# UNITED STATES PATENT AND TRADEMARK OFFICE

APPLICATION NO.	FILING DATE	FIRST NAMED INVENTOR	ATTORNEY DOCKET NO.	CONFIRMATION NO.
10/564,703	05/15/2006	Volker Magderburg	3601	1584
278	7590	05/20/2009		
MICHAEL J. STRIKER 103 EAST NECK ROAD HUNTINGTON, NY 11743			EXAMINER ROHRHOFF, DANIEL J	
			ART UNIT	PAPER NUMBER
			3637	
			MAIL DATE	DELIVERY MODE
			05/20/2009	PAPER

<b>Office Action Summary</b>	<b>Application No.</b> 10/564,703	<b>Applicant(s)</b> MAGDERBURG, VOLKER	
	<b>Examiner</b> DANIEL ROHRHOFF	<b>Art Unit</b> 3637

## **DETAILED ACTION**

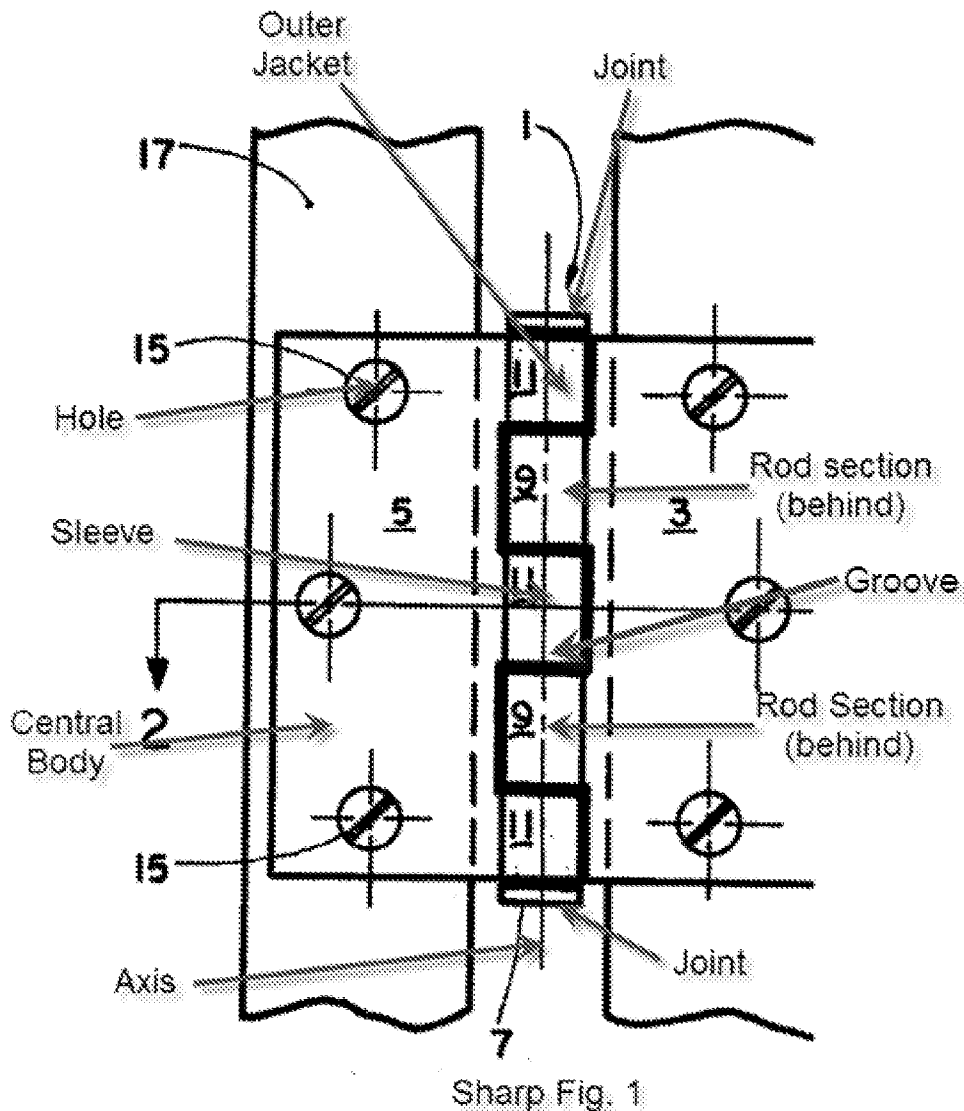
38. Regarding claim 1, Sharp discloses supporting structure with a supporting rod (7) positioned between two joints (see annotated Fig. 1 below), wherein the supporting rod includes at least one pivotable tab (3) positioned parallel to the longitudinal axis of the supporting rod (Fig. 1).

39. Regarding claim 2, Sharp discloses supporting structure wherein a hinge (5) with the tab (3) connects two supporting rod sections (see annotated Fig. 1 below) of the supporting rod.

40. Regarding claim 4, Sharp discloses supporting structure wherein the hinge (5) has a central body (see annotated Fig. 1 below) on which a pivotable sleeve (see annotated Fig. 1 below) is mounted, to which the tab (3) is connected (Fig. 1).

41. Regarding claim 5, Sharp discloses supporting structure wherein the sleeve (see annotated Fig. 1 below) is inserted axially flush into a groove (see annotated Fig. 1 below) in the central body (see annotated Fig. 1 below) (Fig. 1 shows the sleeve and groove are flush with each other).

42. Regarding claim 6, Sharp discloses supporting structure wherein the sleeve (see annotated Fig. 1 below) is inserted radially flush into a groove (see annotated Fig. 1 below) in the central body (see annotated Fig. 1) (Fig. 1 shows the sleeve and groove are flush with each other).

43. Regarding claim 7, Sharp discloses supporting structure wherein the geometry of the outer jacket (see annotated Fig. 1 below) of the central body (see annotated Fig. 1 below) with the inserted sleeve (see annotated Fig. 1 below) corresponds to that of the supporting rod or the supporting rod sections (see annotated Fig. 1) (Fig. 1 shows the outer jacket wrapping around the rod sections).

44. Regarding claim 8, Sharp discloses supporting structure wherein the tab (3) is displaced on the sleeve (see annotated Fig. 1) relative to the axis (see annotated Fig. 1 below) by a distance corresponding to the thickness of a door or shutter (17) (Fig. 2 shows the spatial relationship of the tab relative to the sleeve).
